Re: T02043411
8016 Belhaven Avenue, Lots 60 A-B Pasadena

The Department of Health has reviewed the proposed on-site sewage disposal system plans submitted on April 12th, 2016 and has the following comments:

RE: Perc #T02043411
Tax Account #311090005122
Site: 8016 BELHAVEN AVENUE
PASADENA

SKETCH

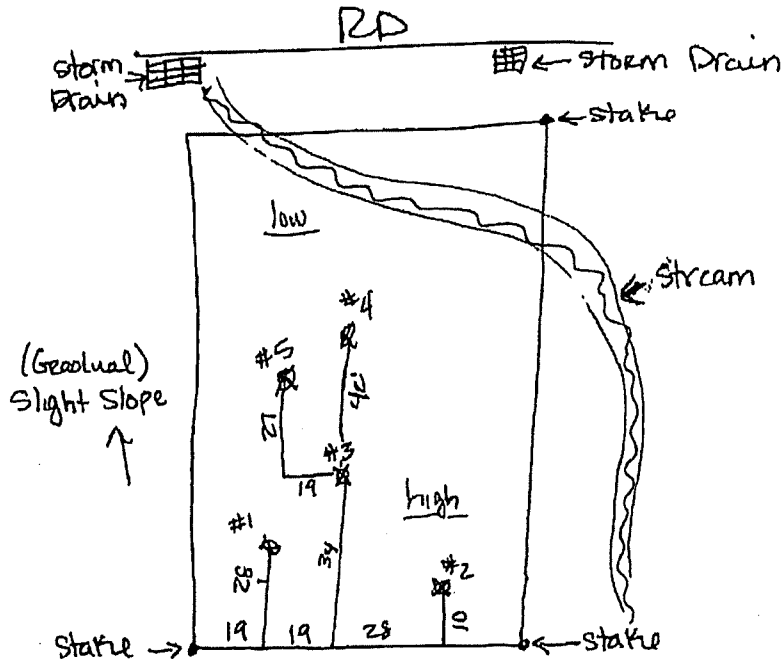
1. Initial mound is a 2' mound. Correct toes to reflect 2' of sand fill.
2. Field notes conflict with locations of perc #100 and #101. If percs were field located and surveyed make note. If they have not been, field locate locations, or see sketch from field notes
